2. **CASE 26.138, 56 PRATT STREET, House, 1857-75 (COLLEGE HILL)**

Proposal: The scope of work proposed consists of Major Alterations and includes:

- As part of the subdivision of the property into two parcels, the applicant is requesting the construction of a two-unit, three-story with cellar addition to the existing building (aka north parcel).

A SOUTH ELEVATION
1/4" = 1'-0"

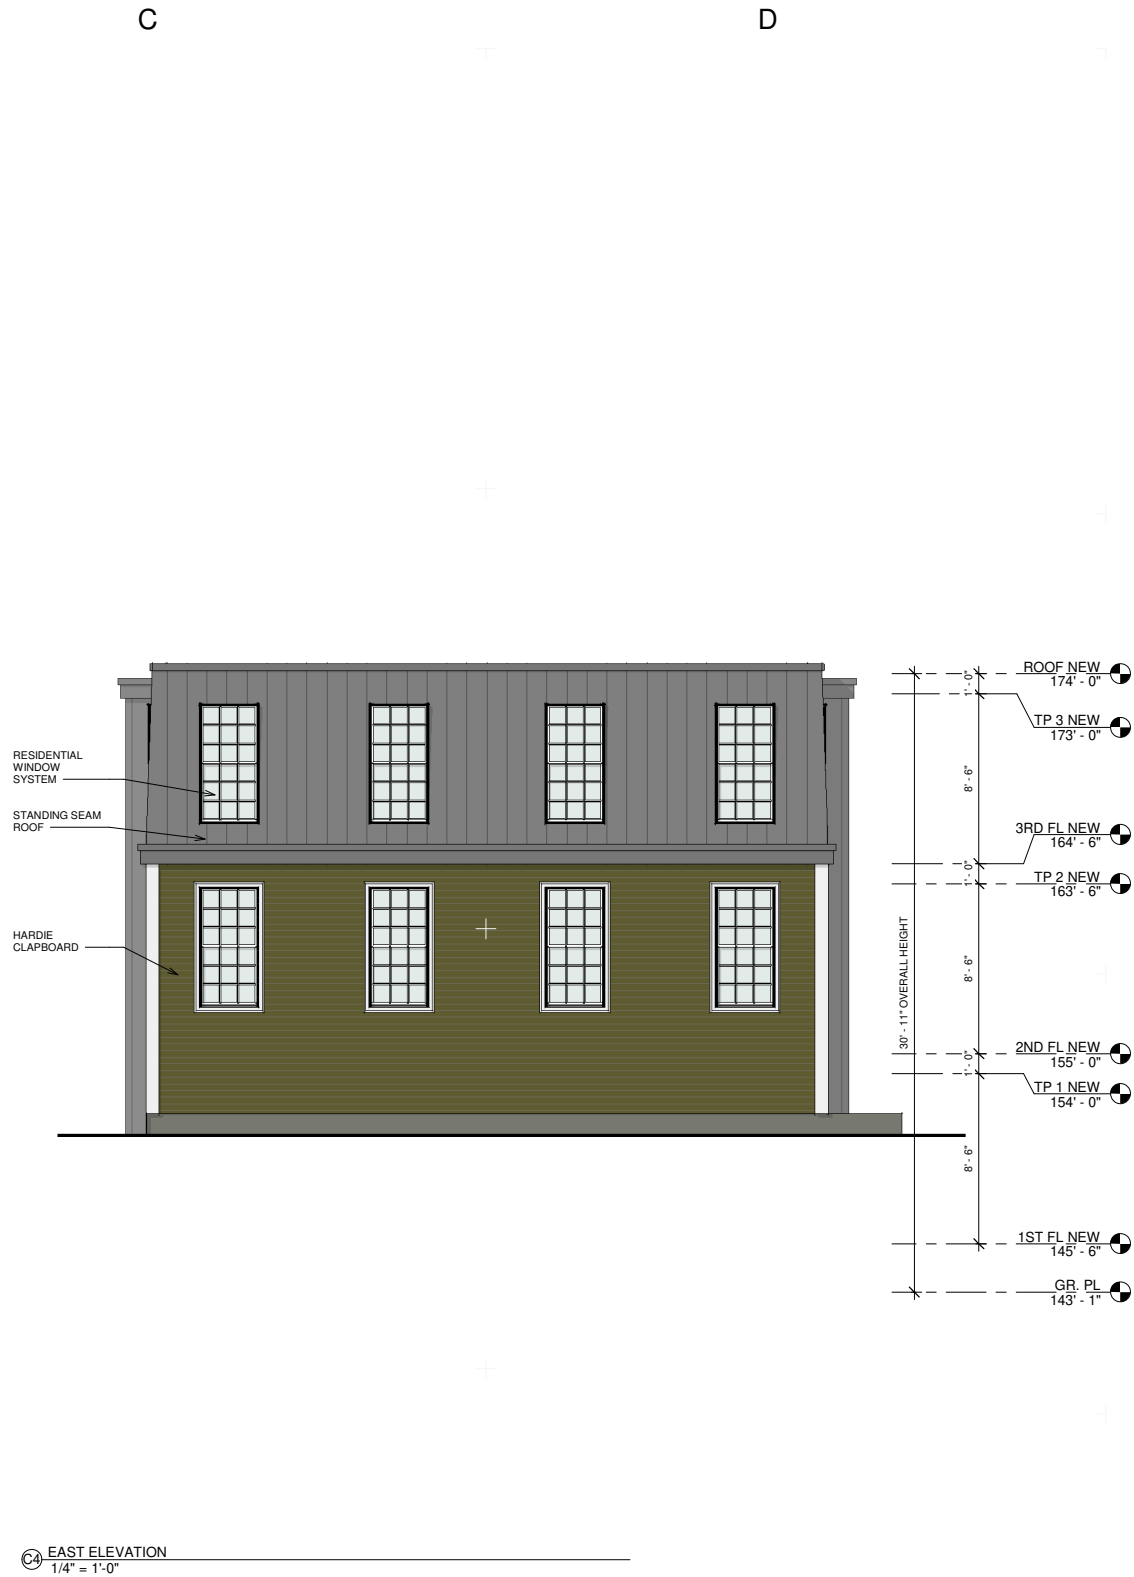
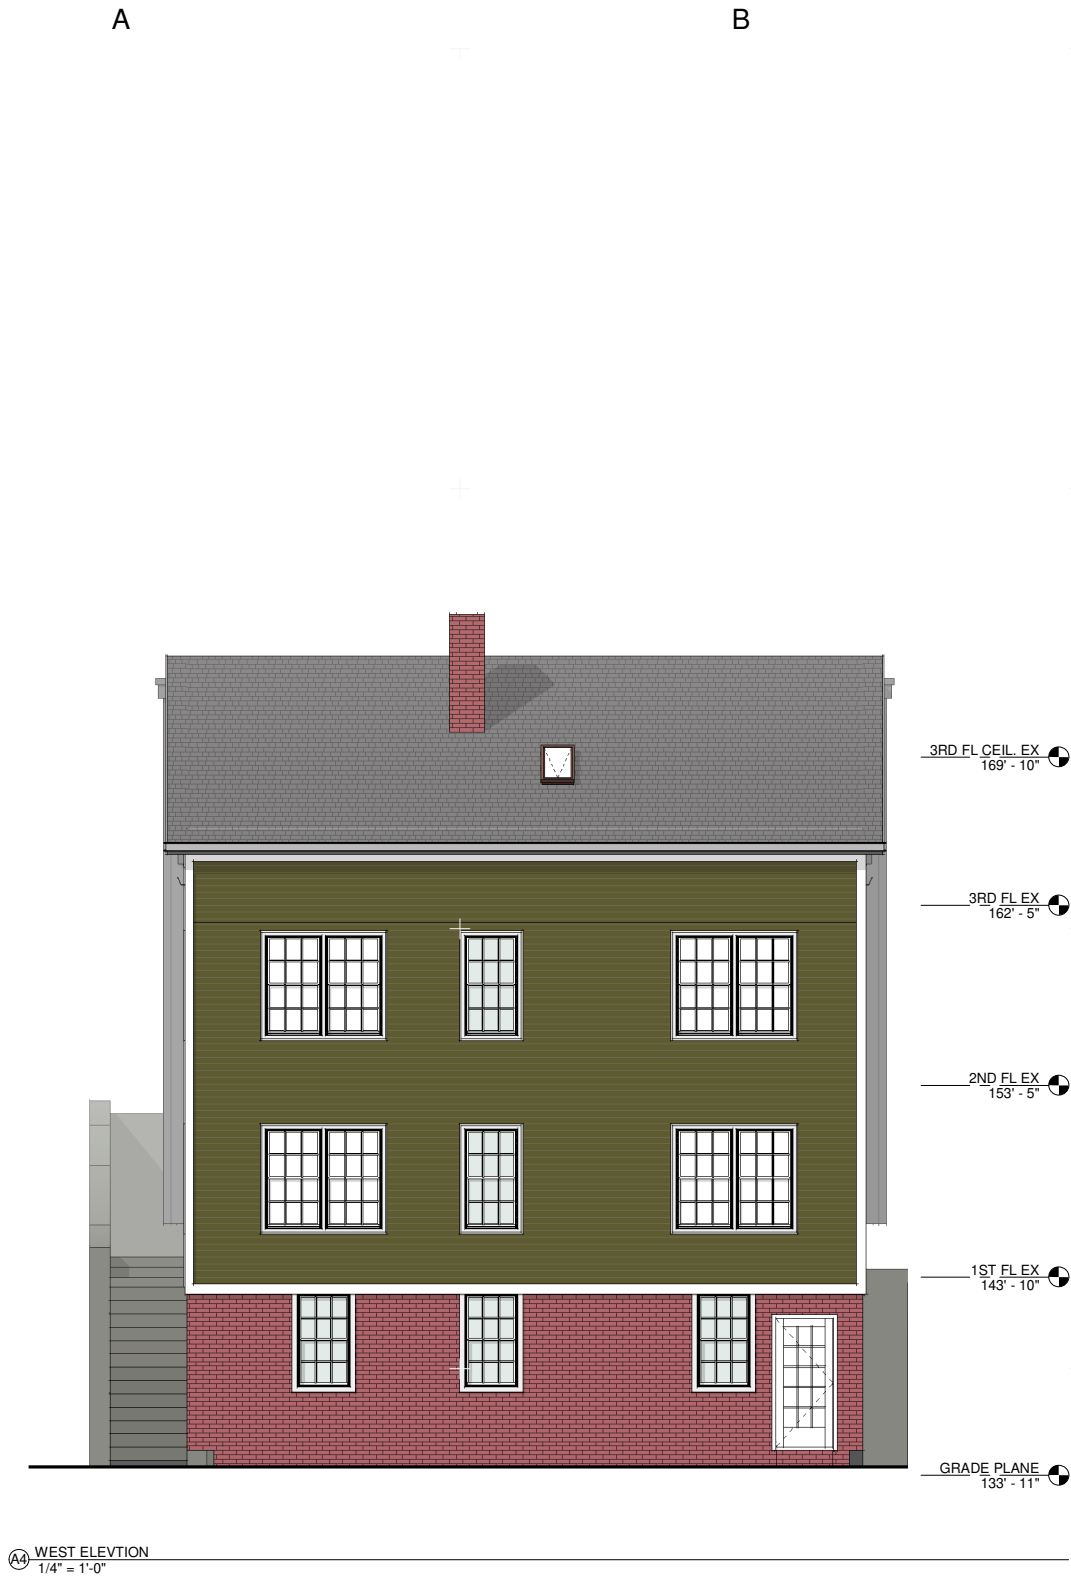
- The applicant appeared at the July 27th meeting. The applicant had revised the drawings, and the proposal was slightly smaller in height but still too large in scale and mass. The upper floor of the addition is a full story above the historic resources' roofline. The submission is not zoning compliant, at minimum not conforming to section 402.A, exceeding the number of allowed stories. It is definitively not subservient to the historic resource. The application was denied (Res26-08);

- The work as proposed is in accord with PHDC Standard 8 being architecturally and historically compatible with the property and district having an appropriate size, scale and form that will not have an adverse effect on the property or district, as the proposed addition is subservient to the historic resource, being of a size where its height and width are minimally to not discernible from the public rights-of-way.
